HIGH-LEVEL WASTE MANAGEMENT PROGRAM PLAN FY 1992 - 1996

FEBRUARY 20, 1991

HIGH-LEVEL WASTE MANAGEMENT PROGRAM SCHEDULE

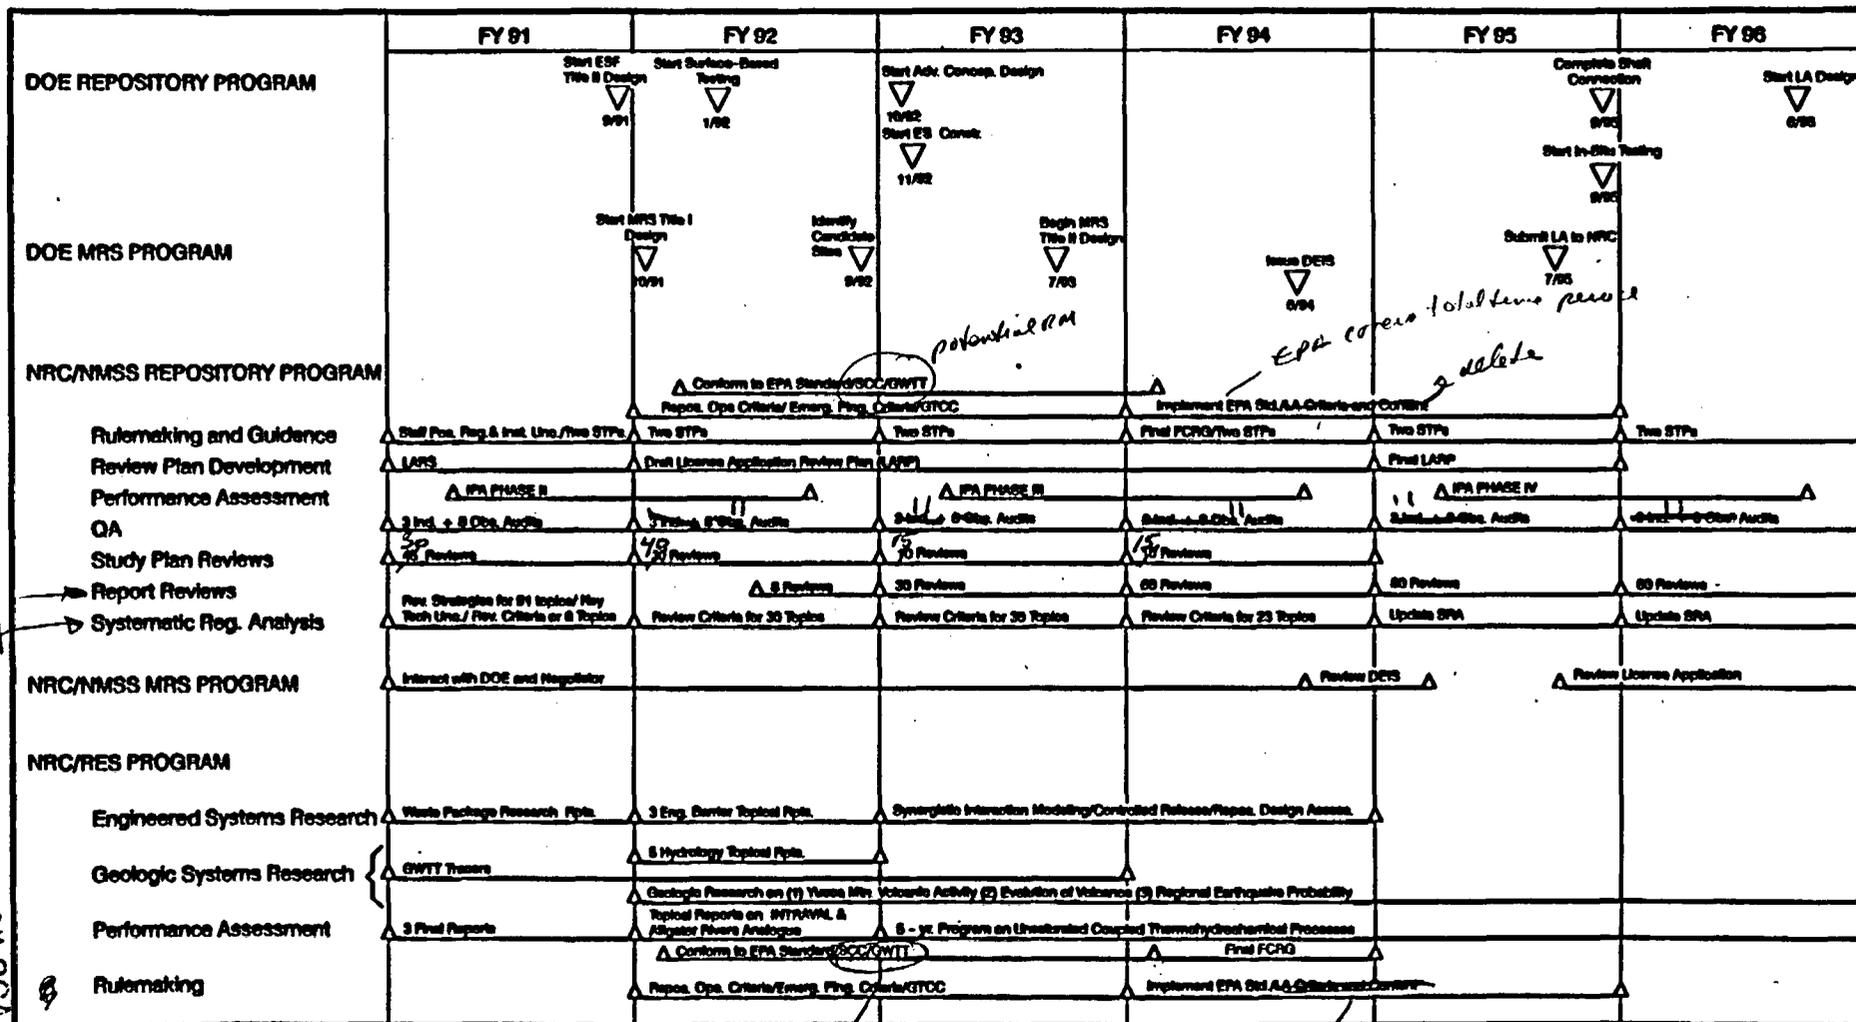
will need to revise after C-3 is final

Figure 1
 potential RAM
 Check completeness of RES timelines. Human intervention reports in 93-95 are not included
 delete
